Bern, 22–26 March 2010

Tanks

Comments on the informal document INF.7 from Sweden

Transmitted by the government of Finland

Elliptical shape

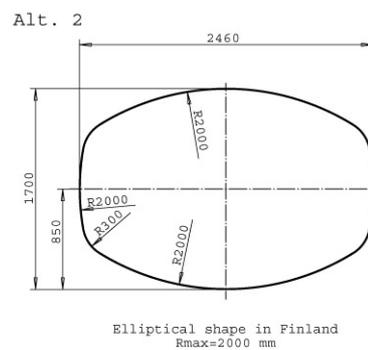
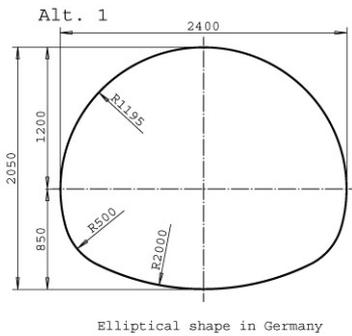
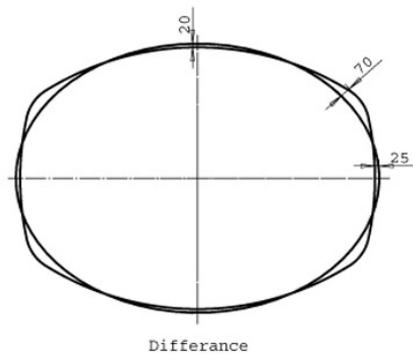
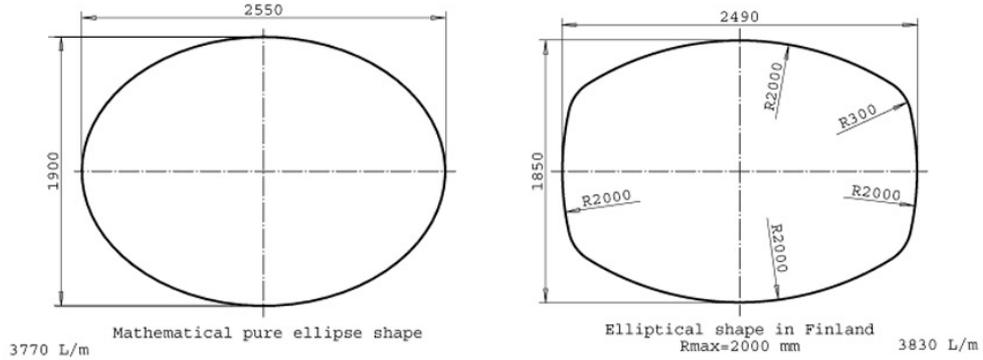
1. In our opinion the term “elliptical” does not mean that the shape of the tank is purely as an ellipse. The meaning “elliptical” gives a bite more flexibility.

2. Pure ellipse shape, where the radius of curvature is continuously changing, is actually not possible to manufacture with non-CNC controlled rounding machine. Many small manufactures still use the non-CNC controlled rounding machines in their production.

3. The tank profile with maximum radius of 2000 on top, bottom and sides and Rmin connection radius of 300 mm in corners is very near to pure ellipse shape. No meaningful differences can be found with the strength of this shape compared to a pure ellipse shape.

4. It is safer to consider this type of tank to an elliptical shape and have the partitions or surge plates after each 7500 litres than to consider the shape as box shape, where even 20 000 litres compartment can be done without surge plates, using the side strengthening of 3 mm aluminium sheet with about 600 mm height on the centreline of their tank (Al normally used for petroleum tanks, according to ADR 6.8.2.1.20 item 4.).

6. Finland considers that the tank is elliptical in the Alt. 1 (elliptical shape in Germany) and Alt. 2 (elliptical shape in Finland) below.
7. Finally, we would like to ask, if it is necessary to consider also the definition of term circular (see Alt 3).

Alt. 3

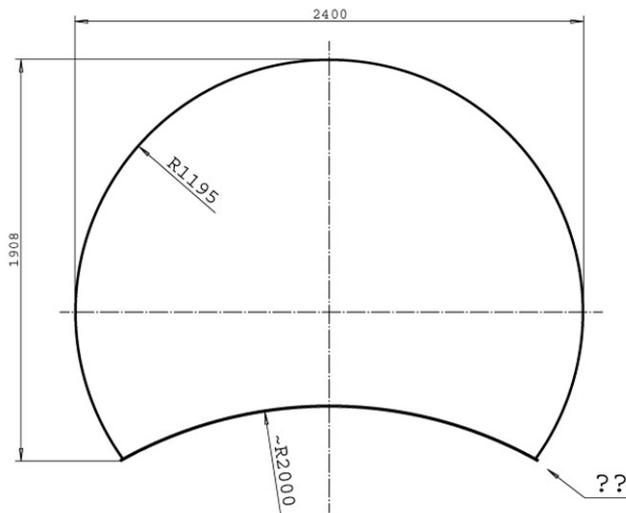
Circular cross section of ADR tank ??
